PZC Resolution No. 2022-021

Comment-and-Issue-Response Summary

Title 21 Text Amendment to Off-Street Parking and Site Access Regulations

PZC Case No. 2022-0026

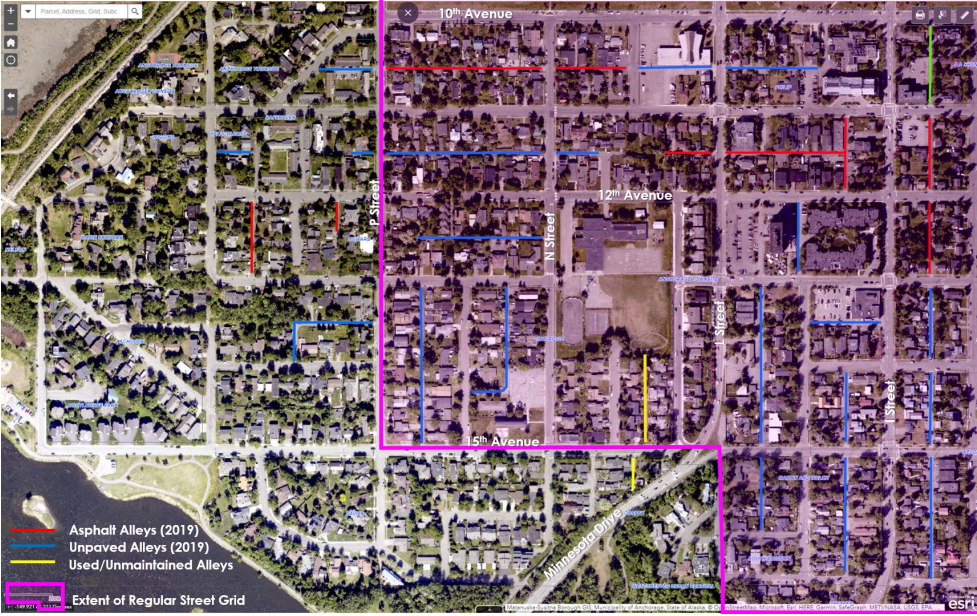
3.	<p>Effectiveness of Parking Reduction Strategies in Reducing Parking Utilization Rates.</p> <p>Several of the proposed mechanisms for reducing parking demand, such as rideshare agreements, parking pricing, unbundled parking from rent, and free public transit passes have not likely been tried in Anchorage. They seem difficult to monitor and enforce, particularly in rental units with higher turnover. Reducing parking requirements to encourage enhanced pedestrian amenities and bicycle parking is admirable but creating more on-street parking problems without a demonstrated decrease in parking demand and adequate enforcement is not an acceptable tradeoff. <i>(Turnagain Community Council)</i></p> <p>The Public Transportation Department offers a rideshare program and programs for organizations to offer transit benefits to their constituents. <i>(Public Transit Advisory Board)</i></p>	<p>Response: Rideshare programs, parking pricing (i.e., unbundled parking), and free public transit pass programs have been used and continue to be in use today in Anchorage (Attachment 6.3, Section 2.1). The Public Transportation Department can track and document continued compliance with any Title 21 Parking Agreement with employers participating in its rideshare program and “U-Pass” free transit pass program.</p> <p>Bicycle parking has been one of the more popular Title 21 parking reductions and is rated highly in the research literature as among the most effective kinds of parking reduction strategies. Some sources indicate a direct correlation between perceived availability of bike parking and the likelihood of bicycling for trips.</p> <p>The <i>Anchorage 2040 Land Use Plan</i> calls for the Municipality to, “Amend Title 21 to allow parking reductions by right for residential uses; offer greater reductions in RFAs and other key development areas.” Developments that employ parking reduction strategies tend to experience lower parking utilization rates. For such developments, the as-of-right percentage reductions yield a more accurate parking requirement.</p> <p>The parking reduction strategies in Table 21.07-9 (pages 32–34 in Attachment 3) refine the existing set of strategies for which applicants receive percentage reductions in required parking under current Title 21. The revised slate of strategies reflects updated research and recent trends and experiences, as documented in Attachment 6.3: Background Research (Section 2.1).</p> <p>RECOMMENDATION: No change.</p>	<p>Approved the Recommendation</p>

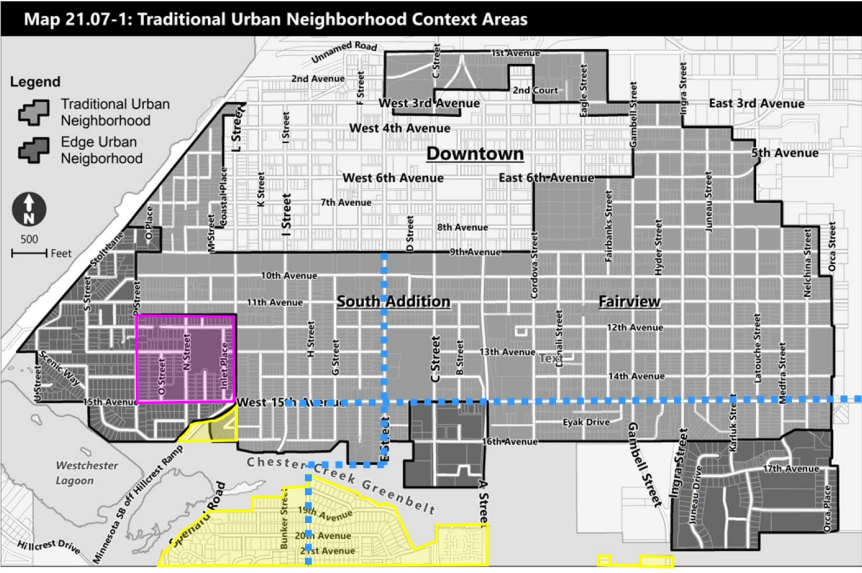
Item #	Comment/Question	Response and Recommendation	PZC Action (6-6-2022)																
Part B: More Complete Menu of Parking Reduction Strategies																			
4.	<p>Parking Reductions for Shared Vehicle Programs.</p> <p>Traffic Engineering is supportive of the revised menu of available parking alternative strategies to include the addition of newer rideshare programs. <i>(MOA Traffic Engineering Department)</i></p> <p>Whereas the amendments propose a 5% reduction in parking minimums if the property owner participates in a rideshare program, a 10% reduction if the owner includes free transit passes, and a 2% reduction if the owner provides a public transit stop or shelter, and whereas the Public Transportation Department offers rideshare and free transit pass programs for organizations to offer to their constituents, the Anchorage Public Transit Advisory Board supports the amendments as written. <i>(Anchorage Public Transit Advisory Board)</i></p>	<p>Response: The project team appreciates these comments, resolution of support, and multiple consultations with Traffic Engineering and Public Transportation Departments that informed the updated menu of parking reductions in Table 21.07-9 for shared vehicle and high-occupancy vehicle (HOV) programs.</p> <p>Public Transportation staff has requested that the Title 21 parking reduction for rideshare programs be offered to property owners and employers who participate in the program but may only partially subsidize the cost. Of the approximately 18 employers that participate in the municipal rideshare (vanpool) program, only one fully covers the cost for its employees to participate. Other employers partially subsidize, and the remainder is grant funded by the rideshare program.</p> <p>RECOMMENDATION: Amend Table 21.07-9, Rideshare Program, (page 32 in Attachment 3) as follows:</p>

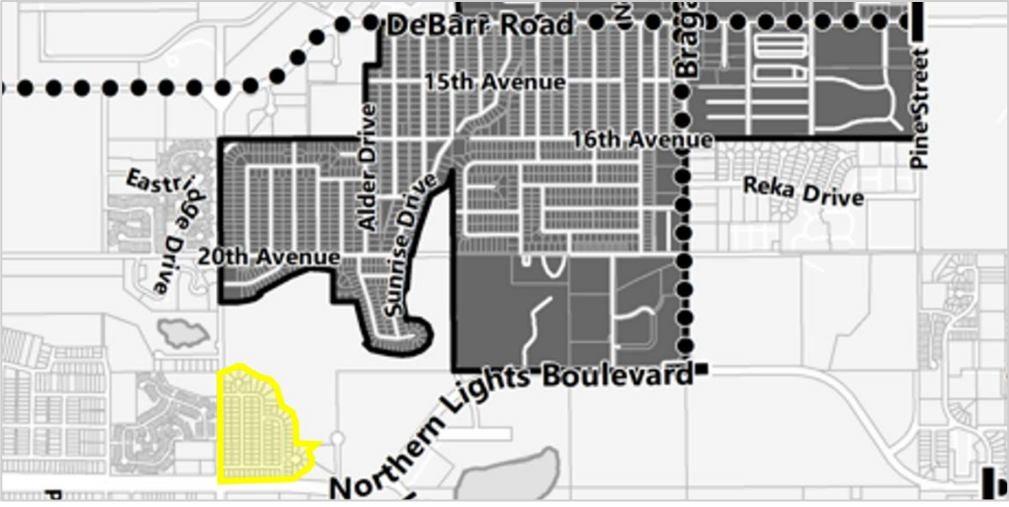
Item #	Comment/Question	Response and Recommendation	PZC Action (6-6-2022)
Part C: Area-Specific, Lower Minimum Parking Requirements			
7.	<p>Map 21.07-1 of Traditional Urban Neighborhood Areas.</p> <p>SACC Planning Committee appreciates the amendments that establish the Traditional Urban Neighborhood Context Area to address the characteristics and context of older neighborhoods like South Addition, and the proposed boundaries generally define the subject area properly for South Addition, a few adjustments are necessary. The map should be revised to include all blocks north of Westchester Lagoon or at least the gridded blocks with alleys in the Traditional Urban Context Area. These are established, fully developed neighborhoods with characteristics more akin to that Context Area. <i>(South Addition Community Council Planning Subcommittee)</i></p> <p>The Neighborhood Context Area maps are great; however, a specific comment that everything south of 15th Avenue should be "Edge Urban." Breaking out only the Eastchester Flats neighborhood (east of the Seward Highway) as "Edge Urban" recalls the tragic history of Urban Renewal in that area. Graphically it may improve the perception of these Edge Urban areas if there was a continuous "Edge Urban" area instead. <i>(Connor Scher)</i></p> <p>Shouldn't the parts of the Edge Urban Neighborhoods from Map 21.07-2 that extend northward show as Edge Urban in Map 21.07-1 too? Also, where does the E St./Arctic Transit-Supportive Development Corridor (dotted line) from Map 21.07-2 begin in Map 21.07-1? In Downtown? <i>(Connor Scher)</i></p>	<p>Response: No objection to extending the boundaries of South Addition’s Traditional Urban Neighborhood Context Area westward to include the regular gridded blocks with alleys west of L Street.</p> <p>Staff surveyed potential revised boundaries. The traditional urban neighborhood pattern with regular gridded blocks and maintained alleys, shaded purple in the map below, extends as far west as P Street. The grid/alley system breaks up west of P Street into irregular street patterns and individual subdivisions, with more changes in topography. This matches in the “Edge Urban” definition. Areas south of 15th Avenue west of L Street, including the Coffey Subdivision, also match the “Edge Urban” character. See map below.</p>  <p>In Fairview, the public hearing draft boundaries on Map 21.07-1 reflect the development pattern of Eastchester (east of Seward Highway, south of 15th Avenue), both historically and currently. Even prior to the 1960s Urban Renewal, Eastchester had a much more informal grid layout than Fairview’s strict grid block pattern with alleys on the plateau north of 16th Avenue.</p>	<p>Approved the Recommended Changes</p>

Item #	Comment/Question	Response and Recommendation	PZC Action (6-6-2022)
		<p>No objection to depicting the Transit-Supportive Development Corridor (TSDC) from Map 21.07-2 on E Street/Arctic Boulevard in Map 21.07-1. Per the <i>Anchorage 2040 Land Use Plan</i>, the TSDC begins at E Street’s intersection with 10th Avenue. The <i>Anchorage 2040</i> TSDC on DeBarr Road/15th Avenue could also be extended into Map 21.07-1 to its western termination at 15th Avenue’s intersection with I Street.</p> <p>RECOMMENDATION: Amend Map 21.07-1 (Section 21.07.015D., page 7 of Attachment 3) as follows:</p> <ol style="list-style-type: none"> Transfer the area between 11th and 15th Avenues and L and P Streets, shown in purple in the map below, from the Edge Urban to the Traditional Urban Neighborhood. South of 15th Avenue, designate Coffey Subdivision east of Minnesota Drive and west of L Street, shown in the small yellow polygon below, as Edge Urban Neighborhood. Clarify that parts of South Addition and Fairview may be in the Edge Urban Neighborhood Context Area recommendation, as proposed in issue #32 recommendation b. Clarify that the portion of North Star Community Council south of Chester Creek Greenbelt is designated as Edge Urban Neighborhood, as shown in yellow below. Depict the Transit-Supportive Development Corridor on Arctic Boulevard/16th Avenue/E Street north to 10th Avenue, and on 15th Avenue east of I Street, as shown in the dotted lines in the map below.

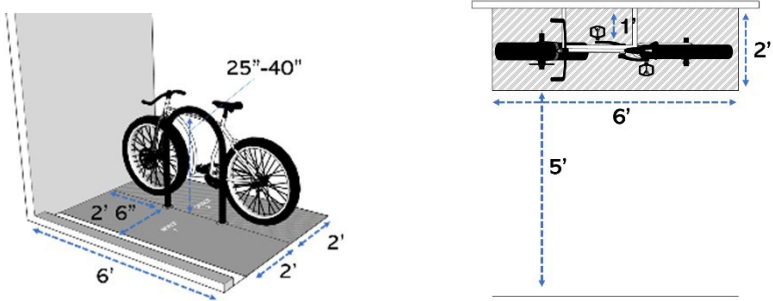
Item #	Comment/Question	Response and Recommendation	PZC Action (6-6-2022)
	<p>the city. Directly funding bicycle parking would be more effective than making bike parking a part of the complex car-parking regulations. Funding would encourage developers to add bike parking to current development. <i>(Bike Anchorage)</i></p> <p>Traffic Engineering supports the changes to the bicycle parking requirements which address both long and short terms needs for non-motorized users. Traffic Engineering has some concerns on how this will be implemented and managed on some developments that are changing the use but are modifying only the building and not the site. An example of this would be a change of use with strip mall type developments where the new use will trigger improvements, but the site has inadequate space to support the requirement. <i>(MOA Traffic Engineering)</i></p>	<p>rights for its lack of bike spaces. If a change of use or building expansion results in an increase in the minimum number of required bicycle spaces, then the number of bike spaces related to the increase must be provided. A tech edit to the parking <i>Applicability</i> section could help clarify. (See recommendation a. below.)</p> <p>A bike space is easier to add to an existing site than a car parking space. Proposed section 21.07.090K.3., <i>Administrative Adjustments</i> (page 63, line 15 in Attachment 3) provides relief if adding a bike space is a practical difficulty on an existing site. This administrative relief provision could be clarified. (See below.)</p> <p>RECOMMENDATION:</p> <p>a. Amend the first sentence in Section 21.07.090B.2. (page 24, lines 12-13, in Attachment 3) as follows:</p> <p style="padding-left: 40px;">2. Expansions, Relocations, and Enlargements A site to which a building is relocated shall provide required parking and loading spaces per tables 21.07-7, 21.07-8, [and]21.07-11, and 21.07-14.</p> <p>b. Amend Section 21.07.090K.3. (page 63, line 15, in Attachment 3) as follows:</p> <p style="padding-left: 40px;">3. Administrative Adjustments The director may approve administrative relief or adjustments to the bicycle parking requirement for changes of use or modifications to existing developments, provided the applicant demonstrates the adjustment is necessary to compensate for a practical difficulty of the site. <u>The department shall keep record of the approved adjustment with written findings supporting the adjustment on file and available for public inspection.</u></p>

Item #	Comment/Question	Response and Recommendation	PZC Action (6-6-2022)
		<p>d. Bicycle parking spaces shall be designed so that the bicycle may be added or removed without having to move another bicycle.</p> <p>i. There shall be a minimum of five feet of clear space inclusive of a walkway, behind the [TWO-BY-SIX-FOOT (OR ALTERNATIVE DIMENSIONED)] parking space to allow room for bicycle maneuvering.</p> <p>ii. There shall be a minimum of two-foot six-inch clearance from all sides of the bicycle rack to walls, fences, curbs, and vehicle parking and circulation areas, or other obstructions, except [THAT] for racks provided in iii.</p> <p>iii. Horizontal bike parking spaces (securing the bicycle horizontal to the ground) with racks attached to walls shall have a minimum one-foot clearance from the rack to the wall, as shown in the second figure below. Vertical and stacked spaces have no required wall clearance.</p> <p><i>(Note to PZC: The right-hand figure below is proposed to be added. It was not in the public hearing draft. The left-hand figure is in the public hearing draft and is not changed.)</i></p>

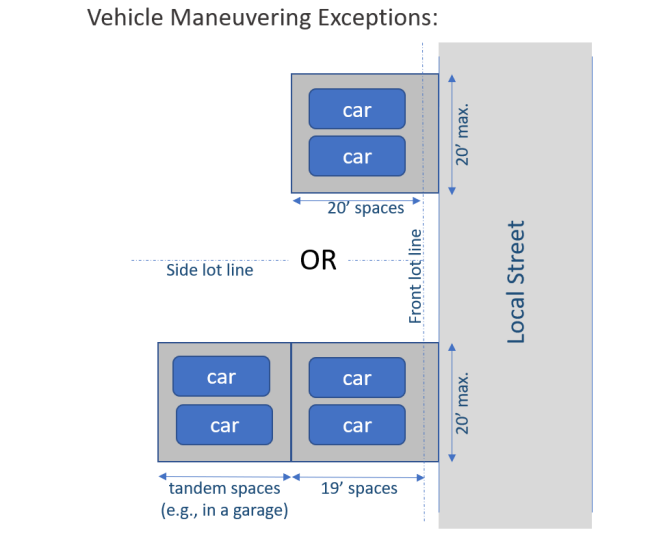
36.	<p>Determining which Parking Spaces on a Site Plan are Eligible for Small Dimensions.</p> <p>Traffic Engineering is appreciative of the changes made to the parking angle, stall, and aisle dimensions, however has concerns with proposed exception 21.07.090H12.a.ii. (Page 58 in Attachment 3) that allows for 50% of spaces to be smaller dimensions for employee only, structured parking facilities, and low parking uses. This provision may need additional</p>	<p>Response: The comment comprises three main questions:</p> <ol style="list-style-type: none"> 1. What defines low turnover uses; 2. How are the spaces for low turnover uses to be identified; and 3. Can the Municipality require them to be called out in a parking study on the plan? <p>The second and third questions are addressed during the permitting approval process for the site plan. The proposed parking layout site plan should identify which spaces serve low-turnover uses and have smaller dimensions. If the low-turnover parking spaces are not shown on the site plan, and the parking study (if there</p>	<p>Approved the Recommended Change</p>

Item #	Comment/Question	Response and Recommendation	PZC Action (6-6-2022)
	<p>clarification regarding which spaces on a site plan are designated as either employee only or low turnover for both municipal staff who review plans and design professional that develop the site plan. <i>(MOA Traffic Engineering Department)</i></p>	<p>is one) does not address the number of spaces, then that should be a permit reviewer comment. Asking for clarification on a parking layout plan or site plan is common practice by zoning plan reviewers.</p> <p>The answer to question 1 above seems apparent in the second sentence in 21.07.090H12.a.ii. (Attachment 3, page 58, lines 27-30). However, perhaps a simple word change, as provided below, could make it clearer.</p> <p>RECOMMENDATION: Clarify proposed subsection 21.07.090H12.a.ii. (Page 58, lines 27-30, in Attachment 3) as follows:</p> <p style="padding-left: 40px;">Uses with a low parking turnover rate are[COMPRISE] multifamily and mixed-use household living uses, office uses, and educational facility uses other than instructional services.</p>
